Staff Report & Recommendation

Design Review Board

SUBJECT: DRB23-0956
1901 Alton Road – Whole Foods

An application has been filed requesting Design Review Approval for the construction of a new 3-story commercial building, including waivers from the Long Frontage Standards, and a variance from the maximum width for entrance and exit drives, to replace all existing structures on the site.

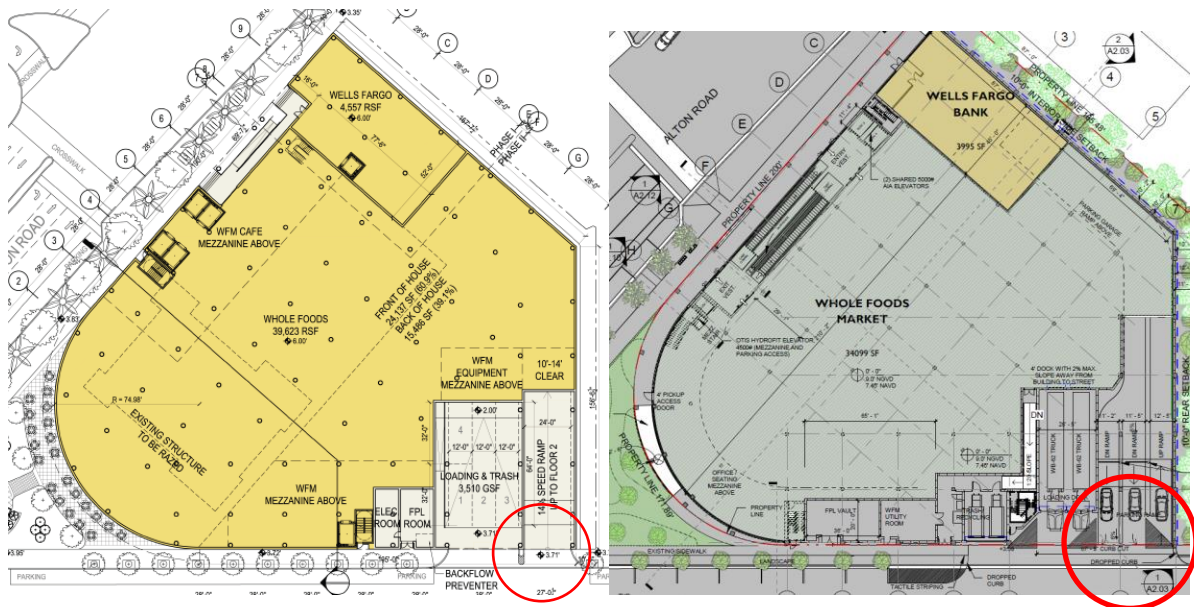
Staff compared the proposed site plan with the plan approved in 2015, and the following is noted:

2 Car driveways
 3 Loading driveways

3 car driveways
 2 Loading driveways
 2 Trash compactors driveways

During the pre-application process, staff expressed serious reservations to the applicant regarding the driveway configuration proposed in comparison to the configuration approved in 2015 and recommended the removal of one of the car exit driveways, as well as reductions in the loading and trash compactor areas, to improve the pedestrian experience along 19th Street. Since the applicant has a surplus of parking on levels 3 to 4, double driveways could be accommodated on the second level to prevent queuing when exiting.
